Item ID: D412-664-203

Item Name: Crosstube Aft

DART AEROSPACE LTD	Work Order:	JS 369
Description: Crosstube High Aft (412)	Part Number:	D412-664-203
Inspection Dwg: D412-664-243 Rev: E		Page 1 of 1

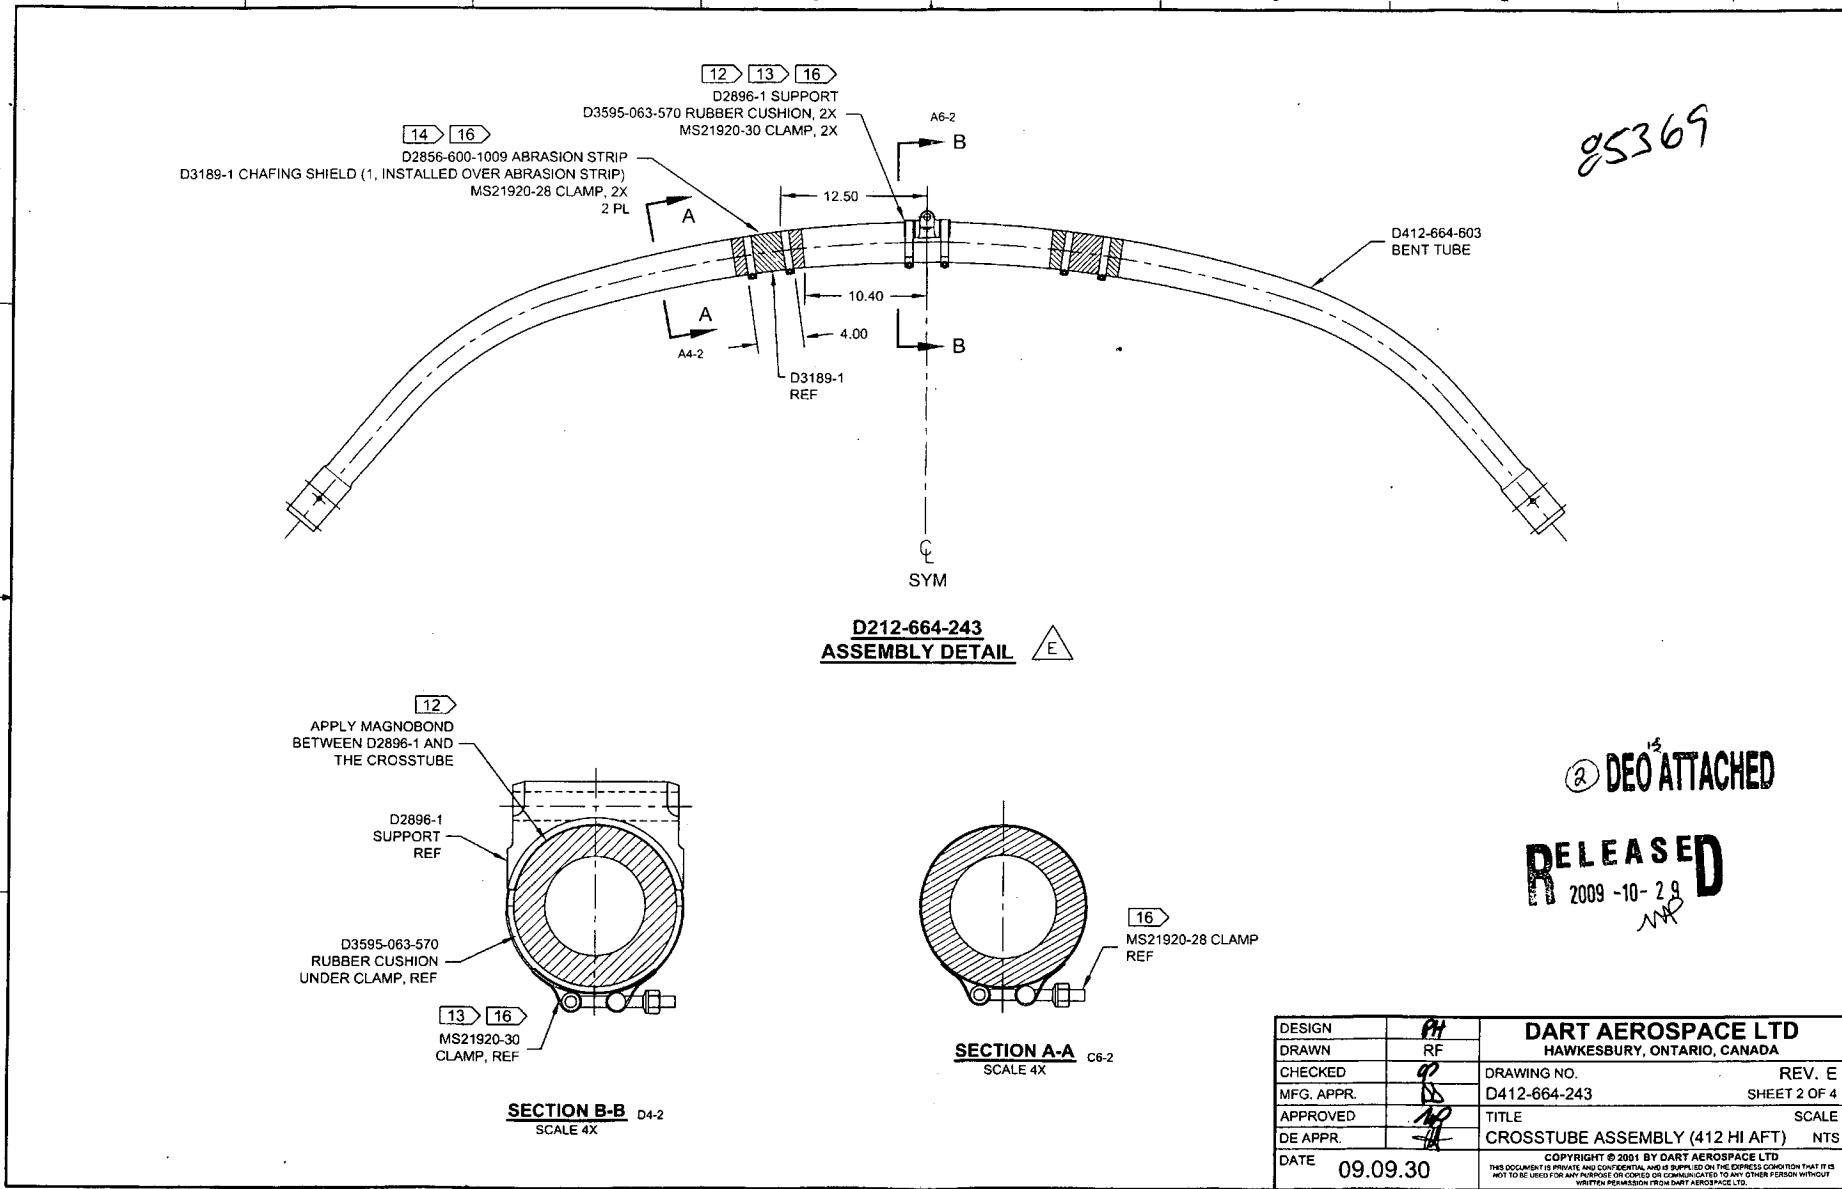
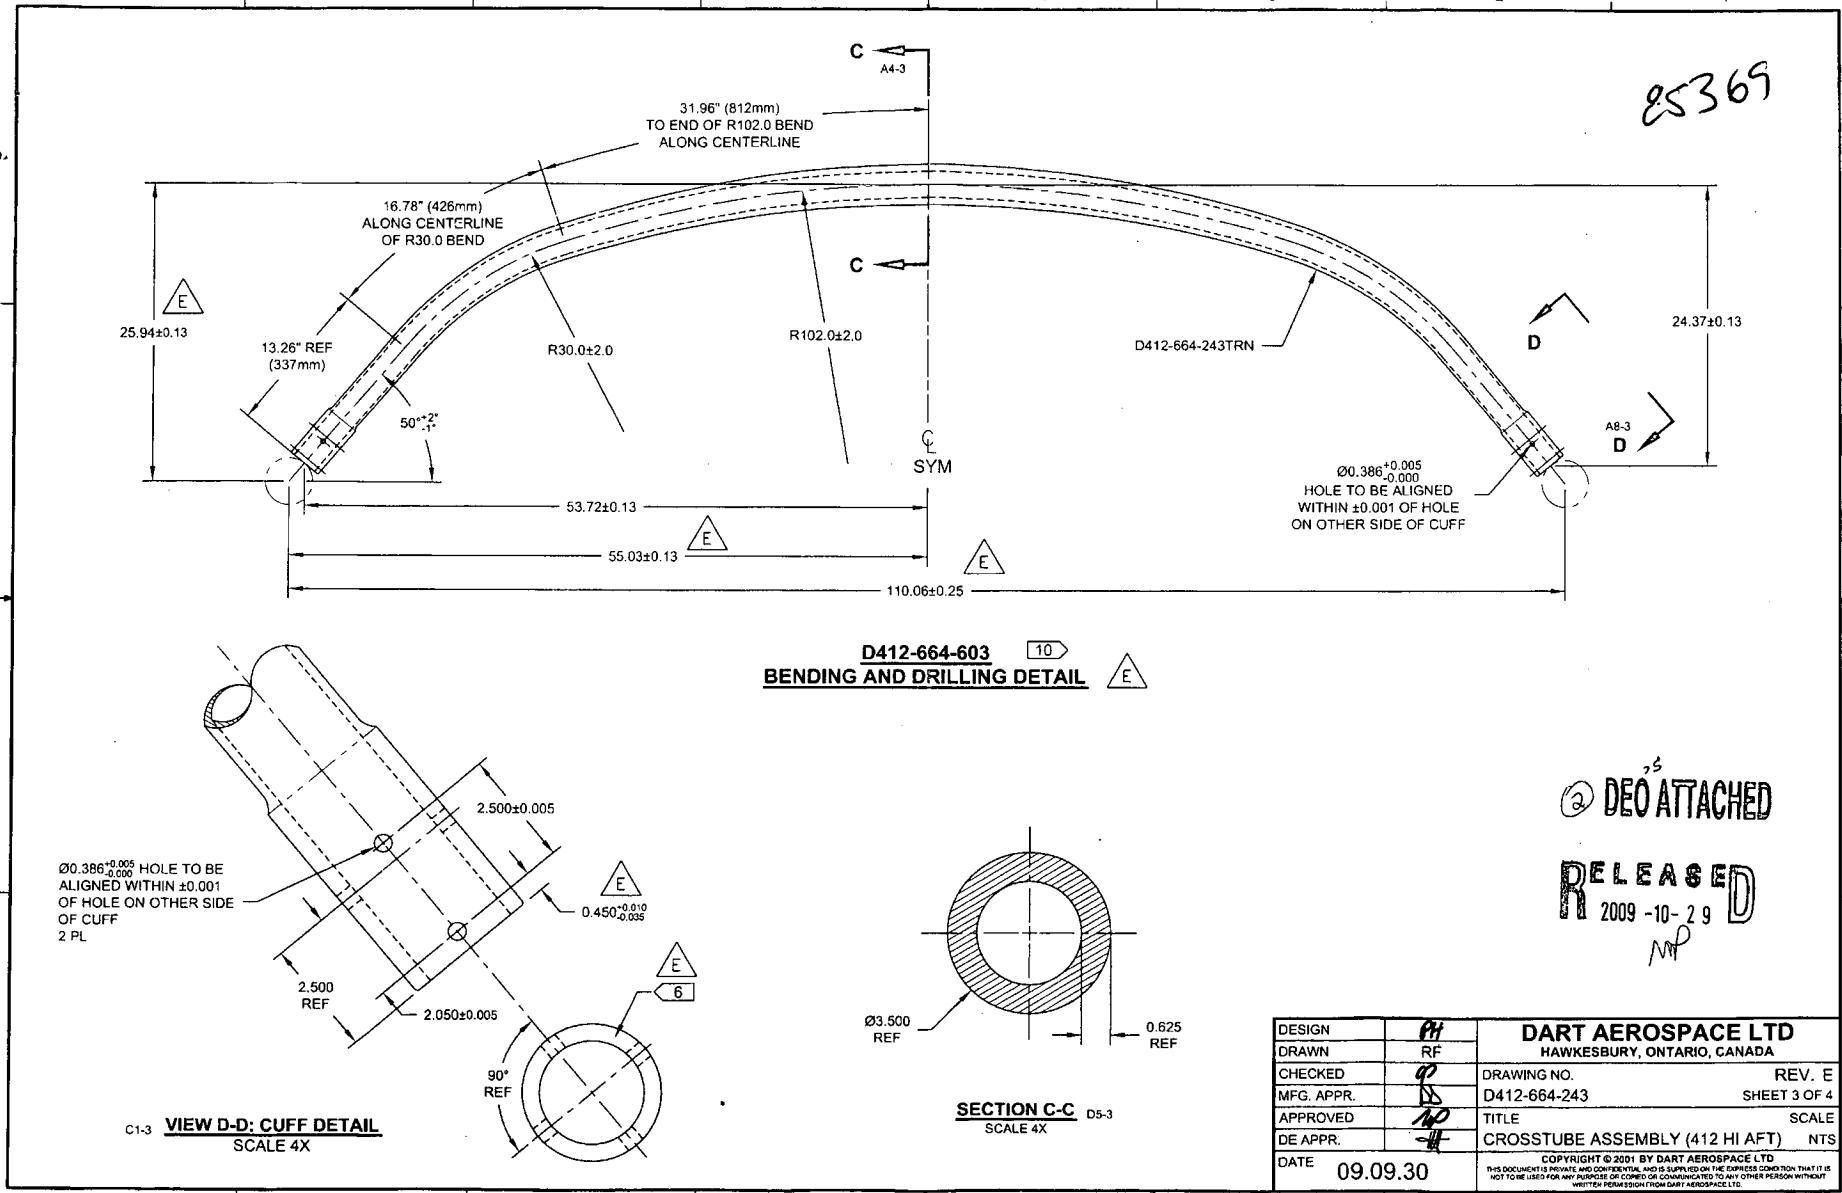
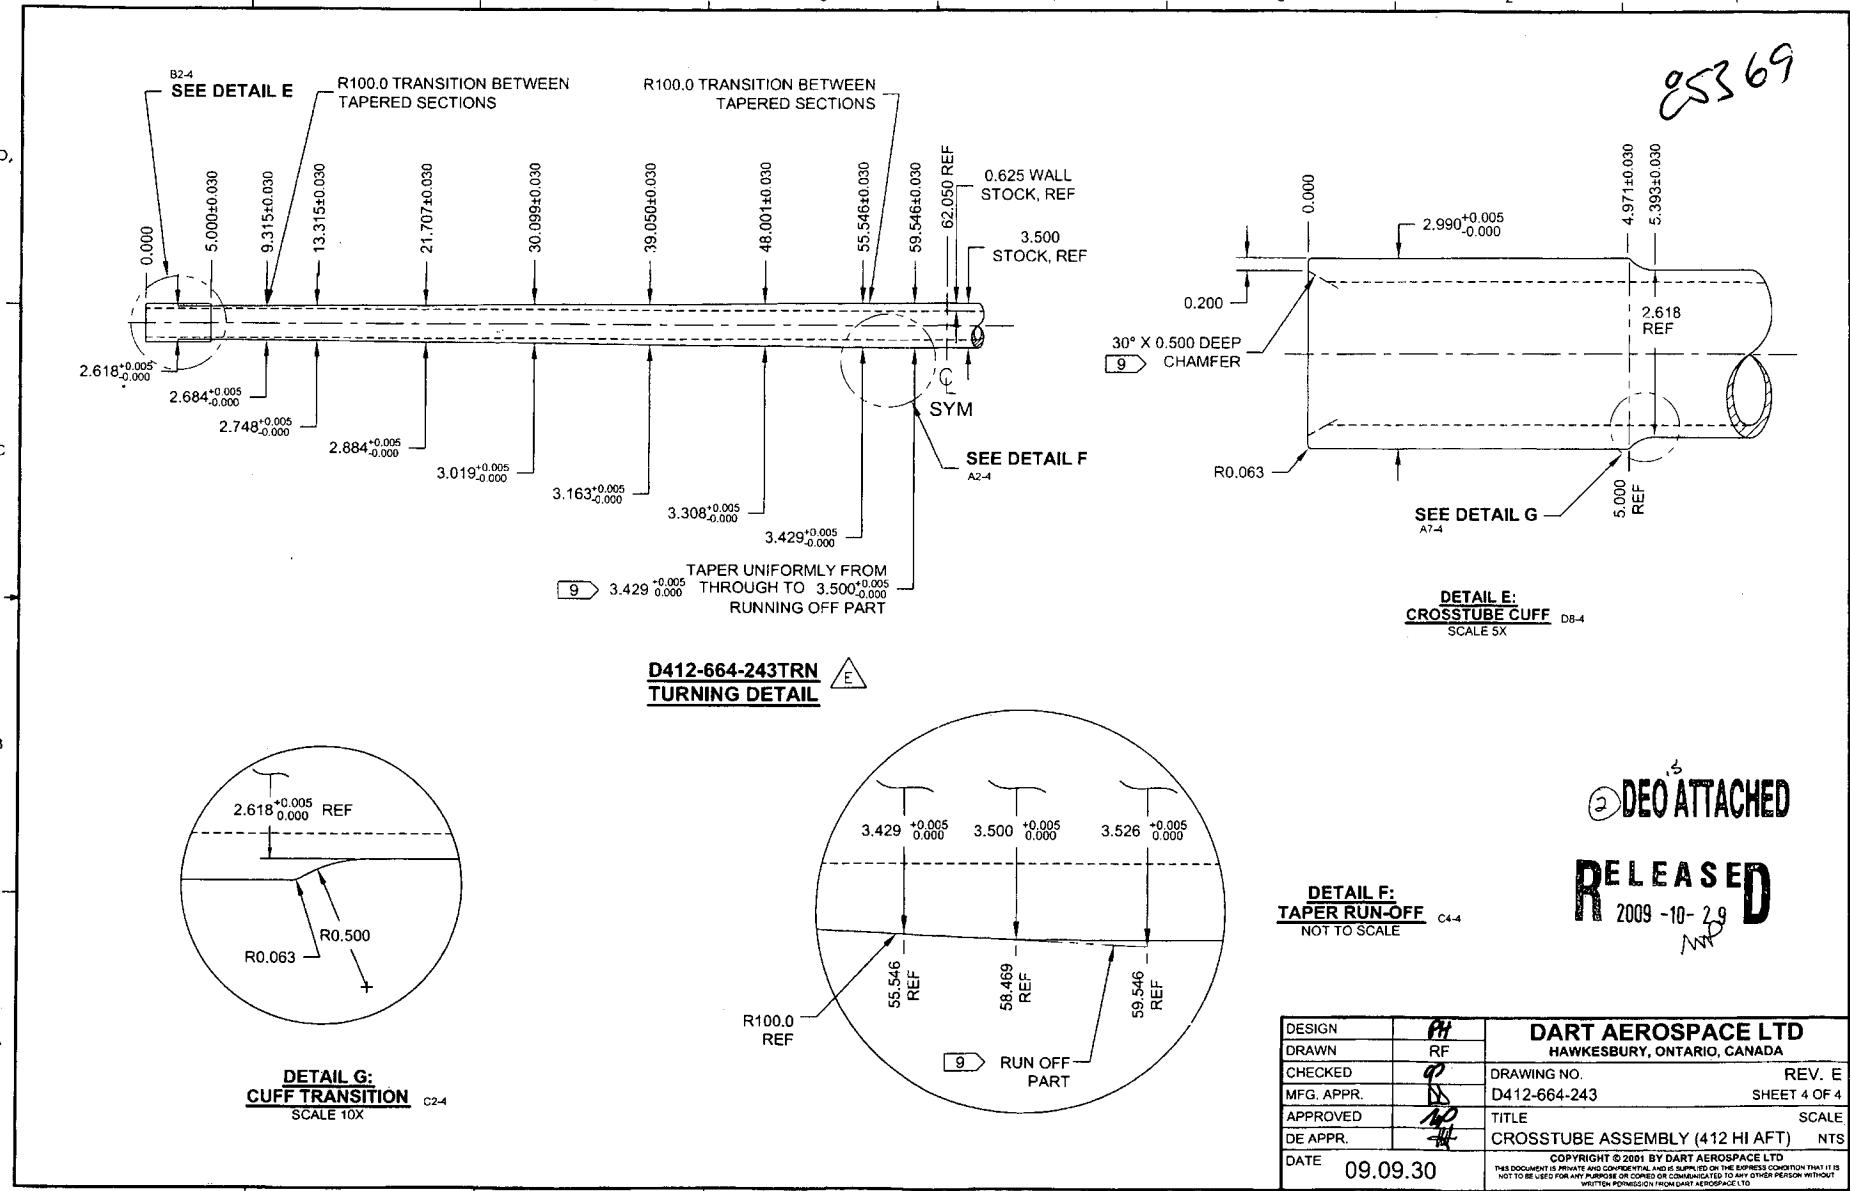
IS:

16 < 14
D3189-1 CHAFING SHIELD (1, INSTALLED OVER PROSEAL 890)
MS21920-28 CLAMP, 2X
2 PL

WAS:

14 > 16

D2856-600-1009 ABRASION STRIP
D3189-1 CHAFING SHIELD (1, INSTALLED OVER ABRASION STRIP)
MS21920-28 CLAMP, 2X
2 PL

CRUSHING OF D412-664-243

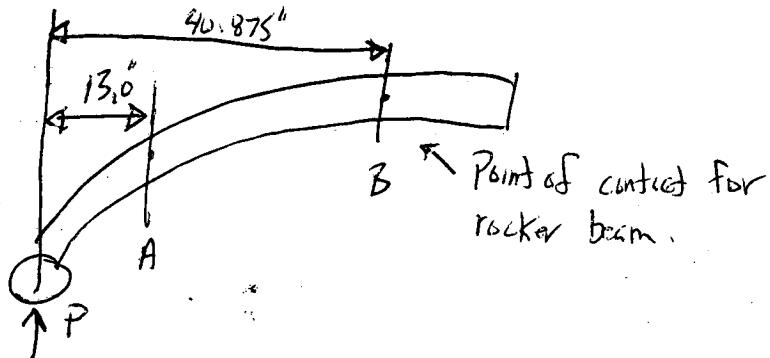
Acceptability of 8% CRUSHING AT END OF BEND

Point A: $OD_1 = 2.961"$, $OD_2 = 2.522"$

$$\text{CRUSHING} = (2.961 - 2.522) / (2.961 + 2.522) = 8\%$$
$$I = 1.676 \text{ in}^4 \text{ (from AutoCAD)}$$

Point B: $OD_1 = 3.307"$, $I = 4.613 \text{ in}^4$

$$A: F = Mc/I = P \times 13 \times 2.961 / 2 \times 1.676 = 11.484 \cdot P$$
$$B: " = P \times 40.875 \times 3.307 / 2 \times 4.613 = 14.651 \cdot P$$

$$M.S. = 14.651 / 11.484 - 1 = 0.27$$

∴ Tube will break at rocker beam contact before area of 8% crushing; 8% crushing in area at end of tube bend is acceptable
